Access Compliance Report

Public Rights-of-Way

(Curb Ramps)

Intersection ID: N/A	Main Street: TRYON_ST	Cross Street: I-485	Location: SE
ADA ID: 21387DB83910	Ramp Type: PerpDiag	Initial Pass/Fail: Fail	Overall Compliance: No
Codes/Mitigation Info/Possible Solution		Field Measurements/Component Compliance	
Severity Score: 13.75

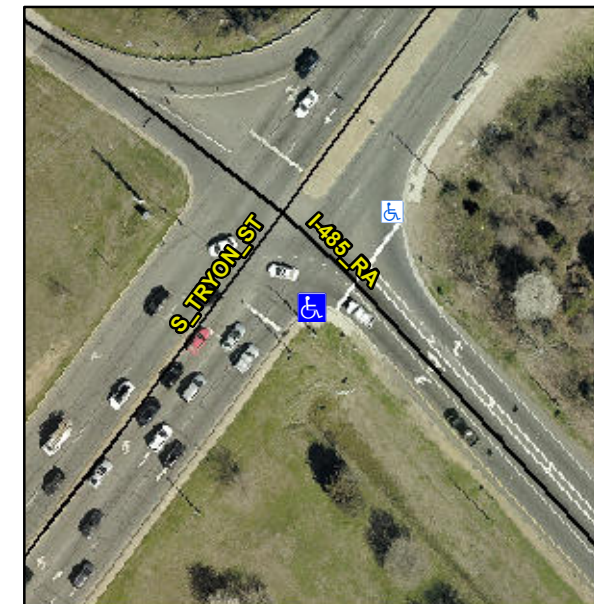
Compliance	Description	Data	Compliance	Description	Data
N/A	Ramp Length (in)	52.0	No	Ramp Slope (%)	8.9
Yes	Ramp Width (in)	48.0	Yes	Ramp XSlope (%)	2.5
N/A	Flare Type LT	N/A	N/A	Flare Type RT	N/A
N/A	Flare Slope LT (%)	N/A	N/A	Flare Slope RT (%)	N/A
N/A	Flare Traversable LT?	N/A	N/A	Flare Traversable RT?	N/A
N/A	Landing Length (in)	N/A	N/A	DWS Provided?	N/A
N/A	Landing Width (in)	N/A	N/A	DWS Contrast?	N/A
N/A	Landing Slope (%)	N/A	N/A	DWS Length (in)	N/A
N/A	Landing X Slope (%)	N/A	N/A	DWS Full Width?	N/A
N/A	Landing Curb? (Y/N)	N/A	N/A	DWS Offset (in)	N/A
N/A	Shared Landing?	N/A			
N/A	Gutter Ponding?	N/A	N/A	Gutter Slope (%)	N/A
N/A	Gutter Lip Ht (in)	N/A	N/A	Gutter X Slope (%)	N/A
N/A	Painted X Walk1?	No	N/A	Painted X Walk2?	No
	X Walk 1 Direction	To NE		X Walk 2 Direction	To NW
N/A	X Walk 1 Width (in)	N/A	N/A	X Walk 2 Width (in)	N/A
	X Walk 1 Slope (%)	4.1		X Walk 2 Slope (%)	2.0
	X Walk 1 X Slope (%)	2.1		X Walk 2 X Slope (%)	1.3

N/A	Ramp inside XWalk1?	N/A	N/A	Ramp inside XWalk2?	N/A
	Road Slope (%)	3.0	N/A	Clear Space?	N/A
	Road X Slope (%)	0.0	N/A	Clear Space to XWalk (in)	N/A
N/A	Any Obstructions?	N/A	N/A	Storm Grate/Utility Hazard?	N/A
	Obstruction Type			Storm Grate/Utility Type	
		N/A			N/A
		Yes		Surface Condition? (G/P)	Good

Remove & Replace Curb Ramp With Two New Directional Ramps or Equivalent.

R304.2.2
